SUBJECT: Forwards open items from Structural Engineering Branch
 811005-08 meeting in Woodbury, NY.

Subject: NUCLEAR PROJECT NO. 2
OPEN ITEMS FROM SEB MEETING

Attached are sixty copies of the open items from the Structural Engineering Branch meeting held in Woodbury, New York, October 5 - 8, 1981.

WNP-2
NRC-SEB MEETING

FIGURE
1
ISSUE
9

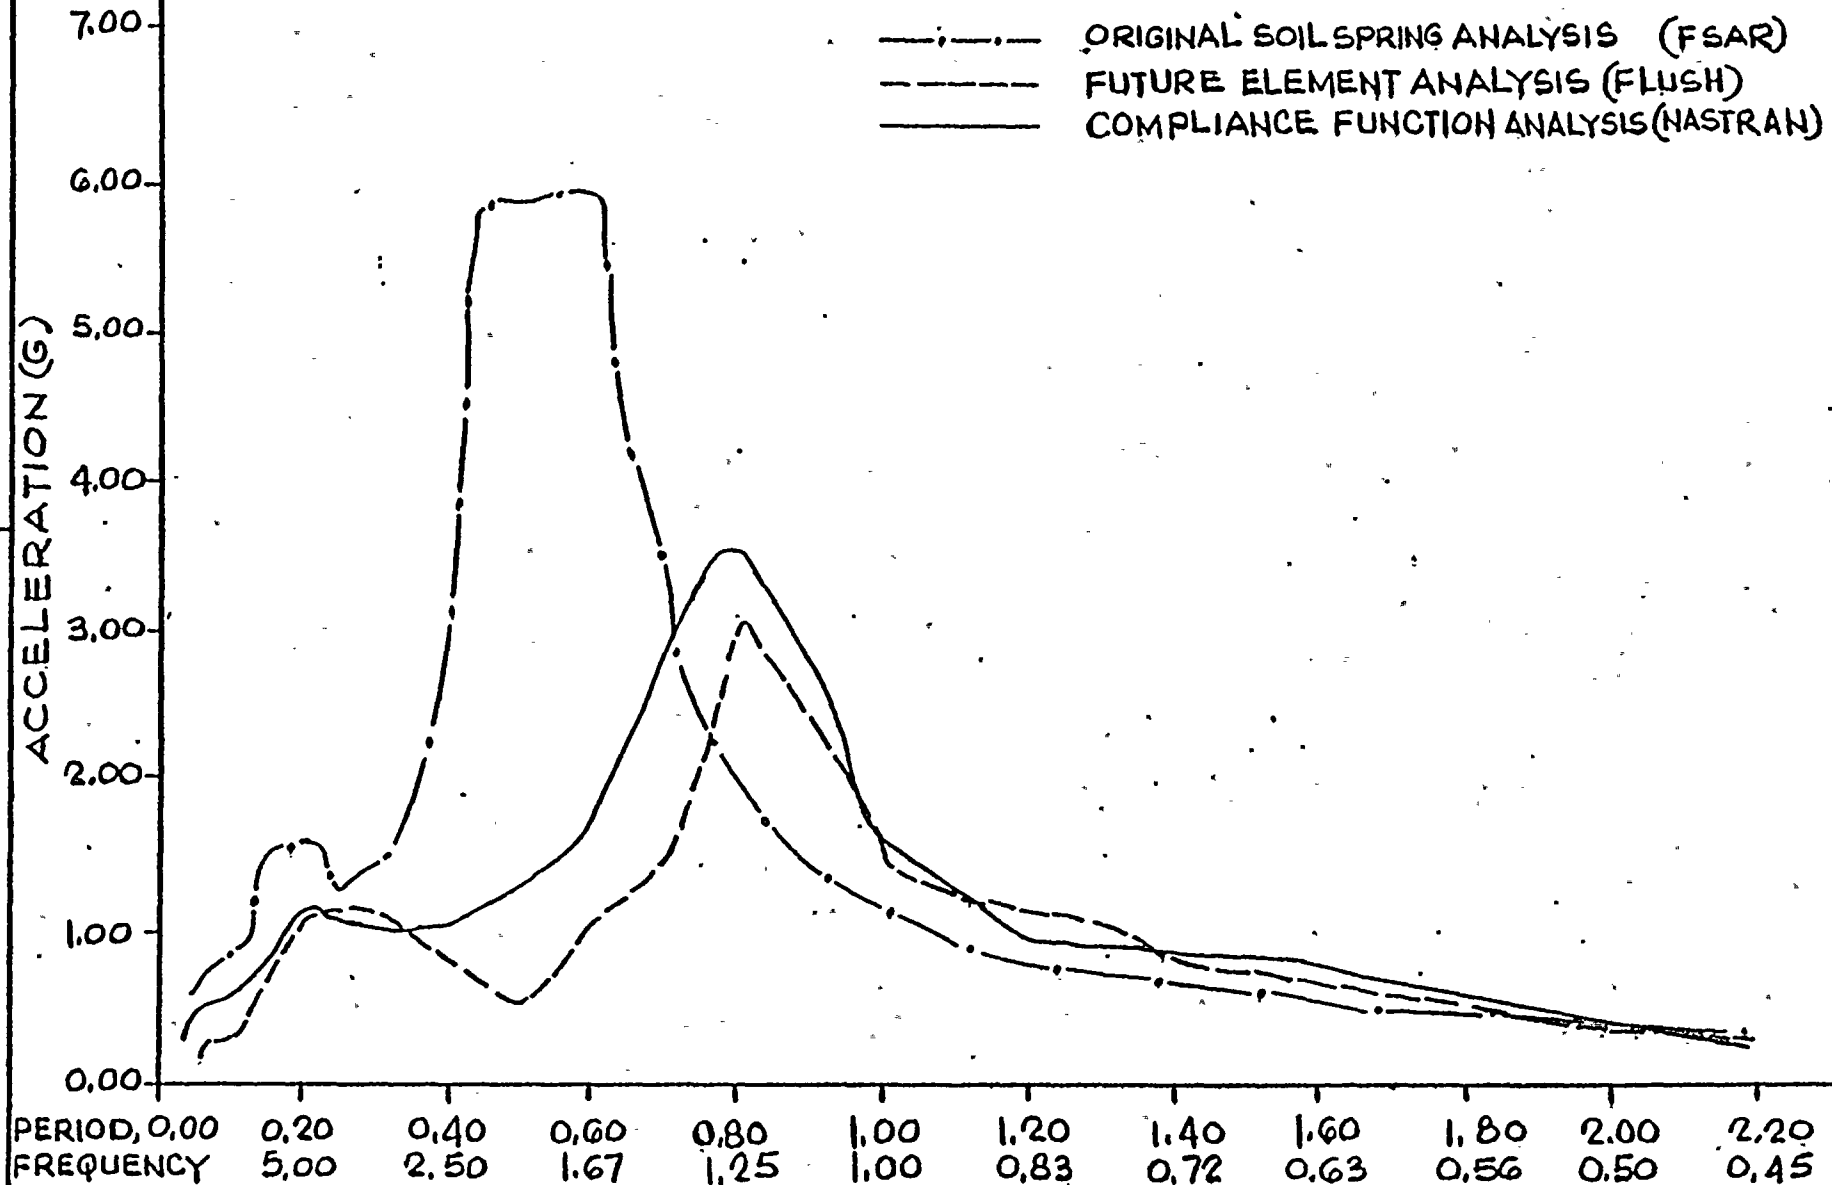
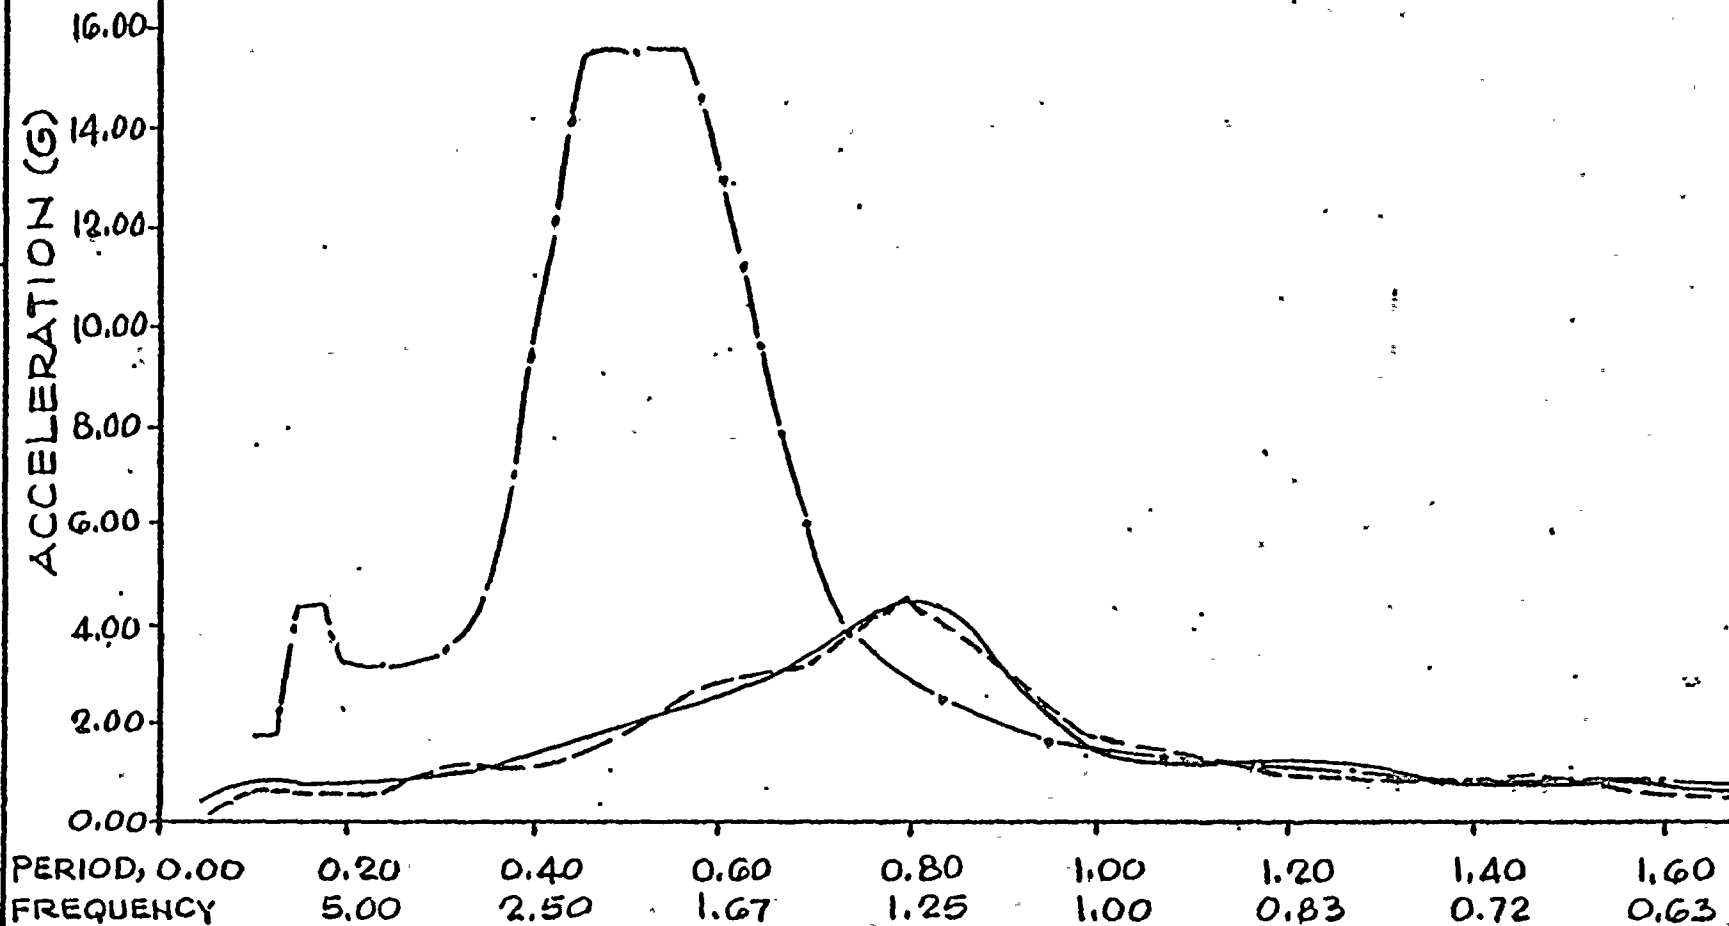
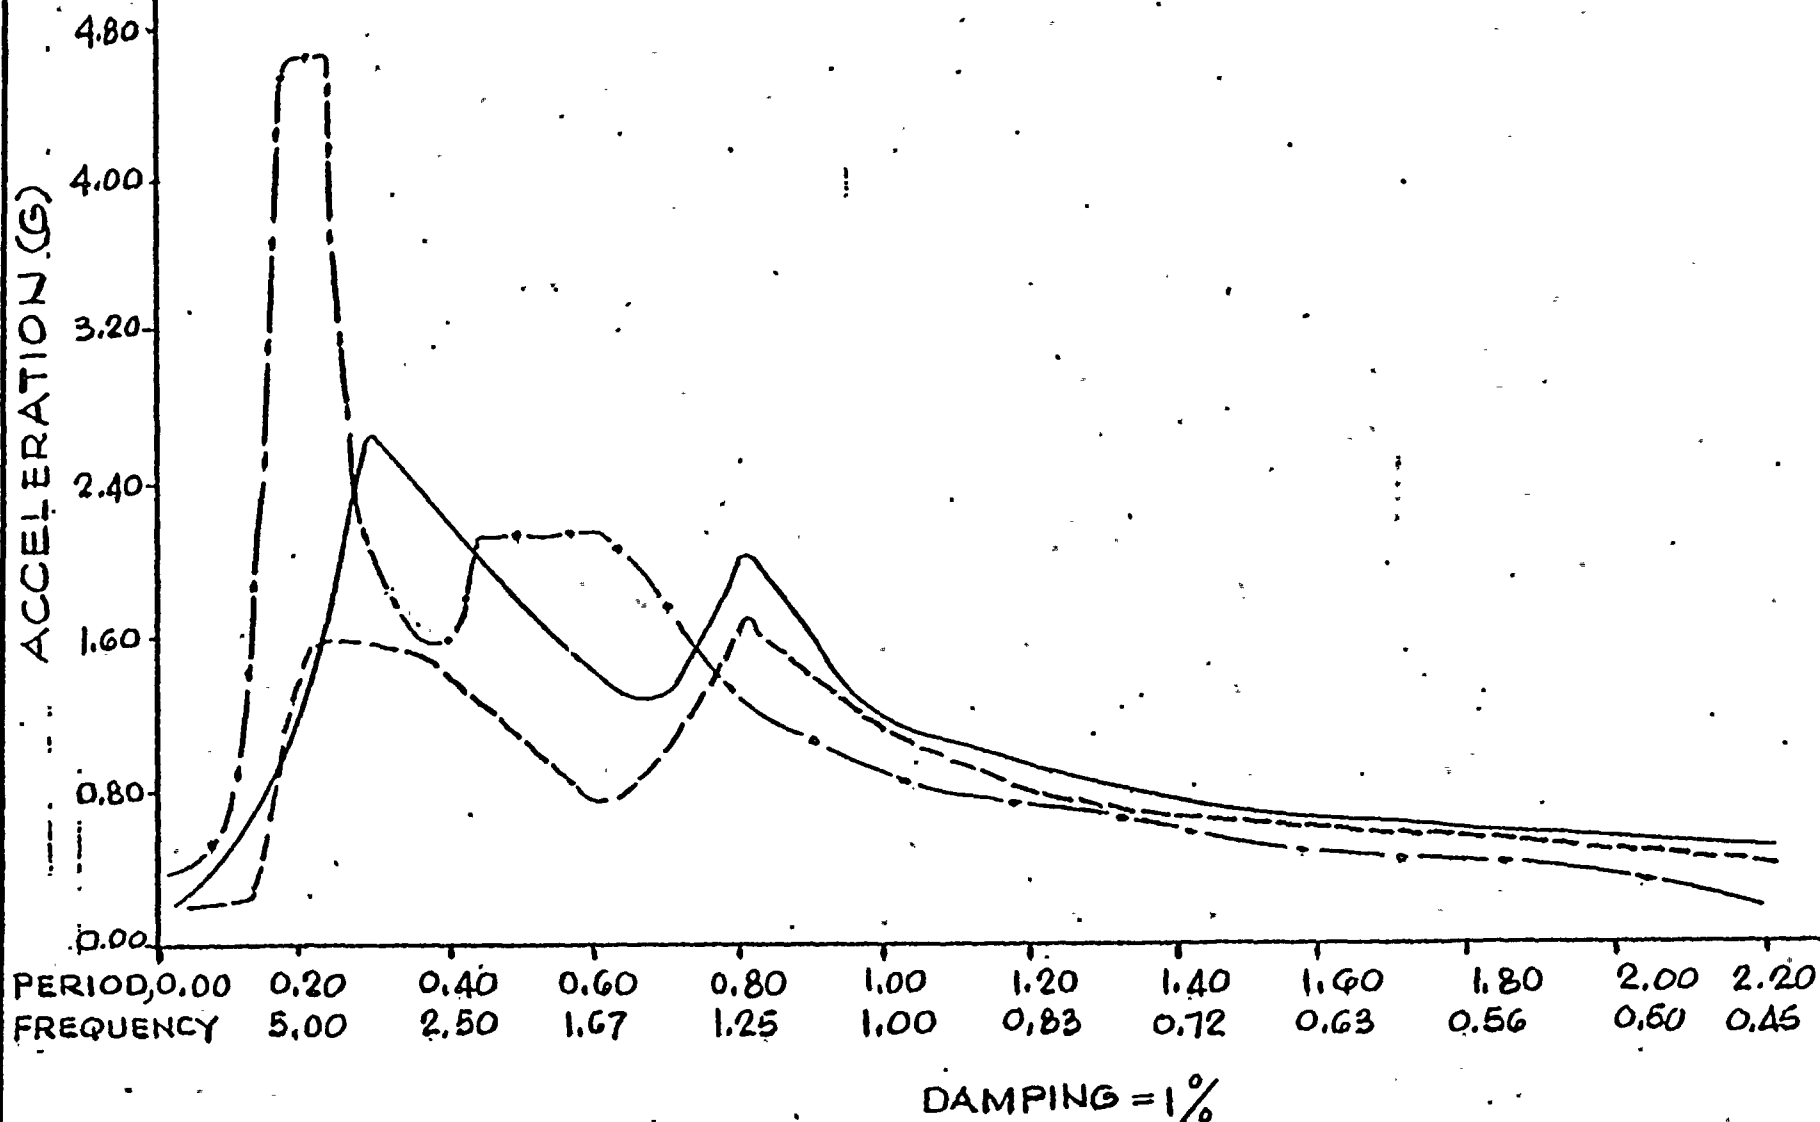
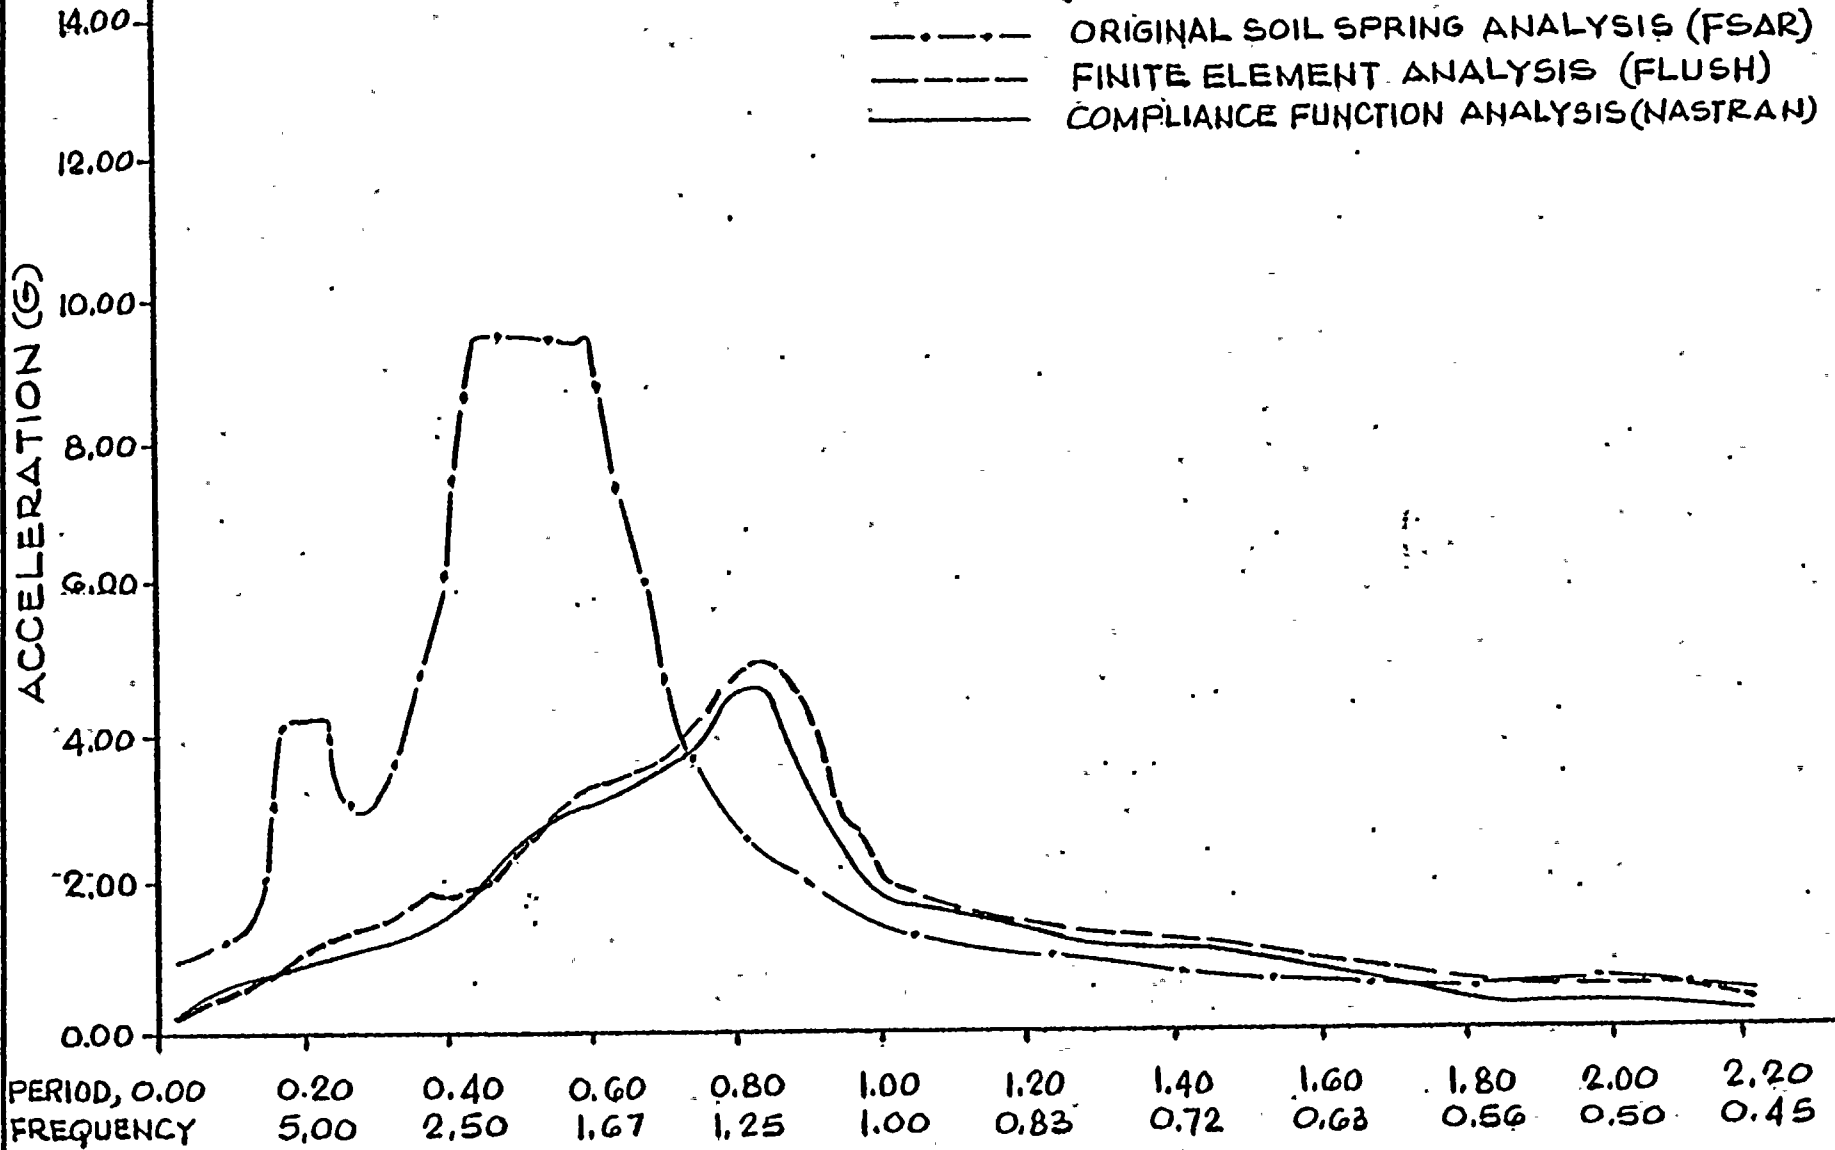
Inspection of the Figures #1 through #4 provided with this response shows that the response spectra developed by the original soil spring analysis (in the FSAR) envelope the finite element (F.E.) FLUSH analysis spectra for frequencies of interest/concern (larger than 1.3 Hz approximately). Since equipment frequencies are higher than 1.3 Hz, this would be acceptable.

The comparison of Figures #1 through #4 also shows that the response spectra developed by the original soil spring analysis (in the FSAR) envelope the compliance function analysis (NASTRAN) spectra for frequencies larger than 1.3 Hz, with the exception of the reactor building mat in the frequency range of 2.2 Hz to 3.6 Hz.

Examination of representative Seismic Category I equipment on the reactor building mat demonstrates that the equipment fundamental frequencies are greater than 3.6 Hz or have been designed to accelerations greater than the exceedance level shown on the respective curves.
